THE CITY OF SAN DIEGO

REPORT TO THE PLANNING COMMISSION

REPORT NO. PC-08-116

SUBJECT: DOTI POINT VIEWS - PROJECT NO. 1481. PROCESS 5

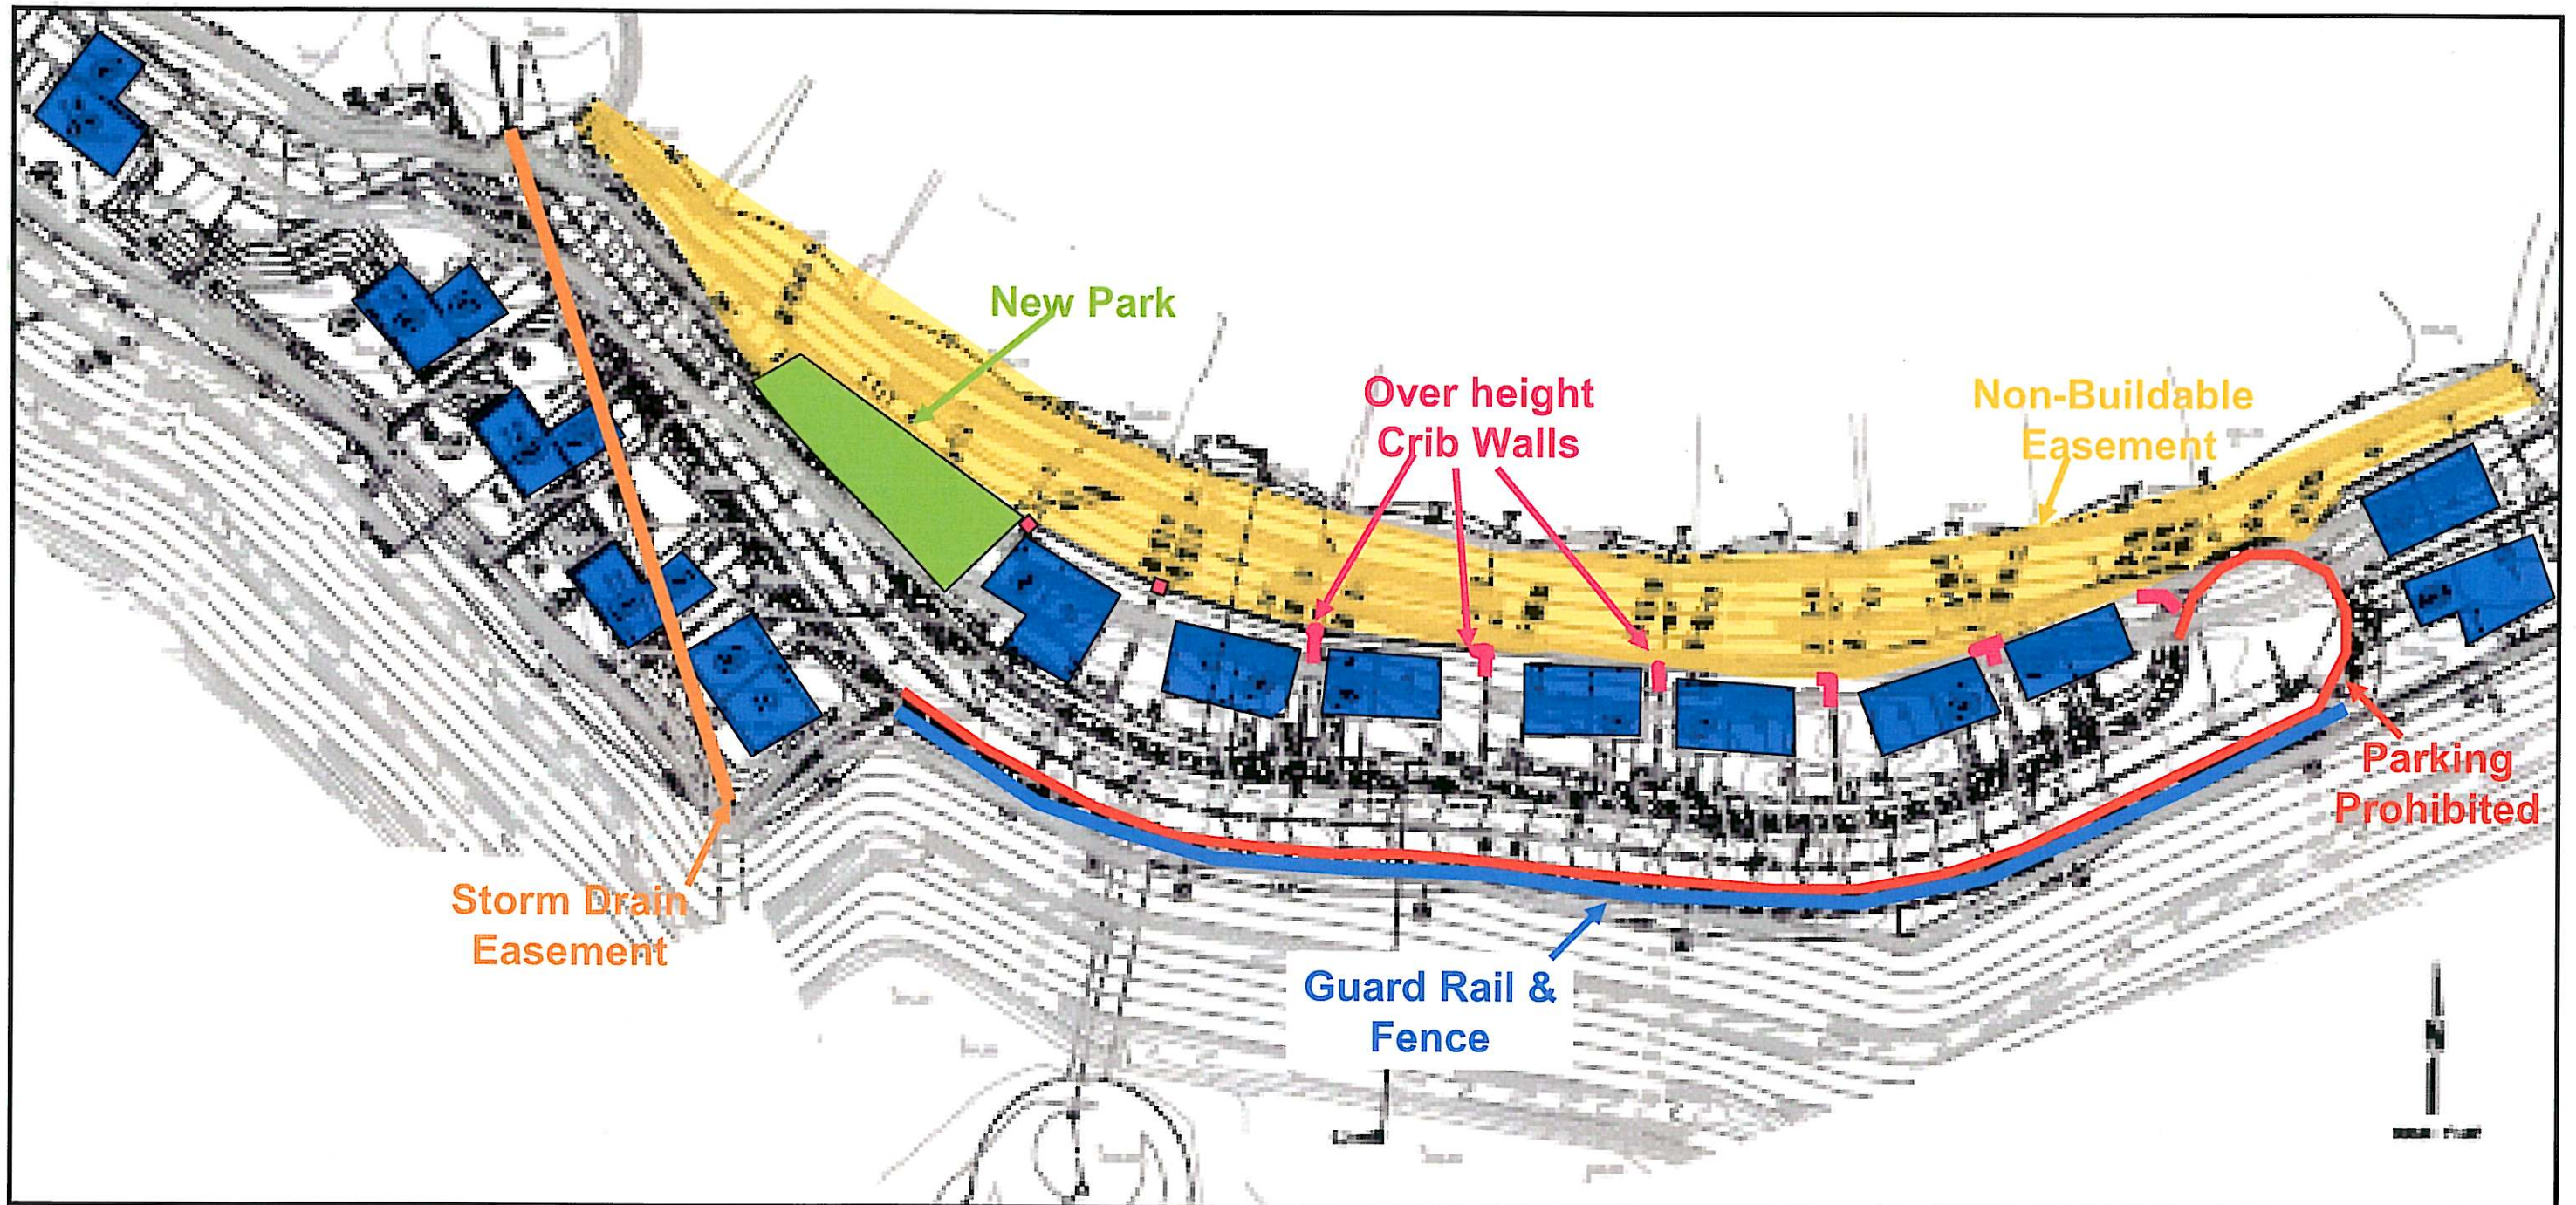
Provide a reveg/restoration plan that is acceptable for the non-buildable slope. People will be looking at it and it should meet the requirements but also be presentable.

Provide a detail on the retaining walls. Recommend that the walls be stepped down and plantable. You have one wall which could be broken up to give a softer appearance, especially on the side walls.

Staff Response: The existing sloped embankment on the north side of the development behind lots 1 through 9 is a manufactured slope containing eucalyptus trees, bushes and non-native grasses. This slope will be maintained by a proposed plantable crib wall ranging in height from 7 to 10 feet for the majority of the wall, with a small segment around the cul-de-sac reaching a height of 12 feet due to the existing topography. As conditioned by the permit, if vegetation is disturbed during construction, it will be replaced and enhanced as shown on the approved landscape plan.
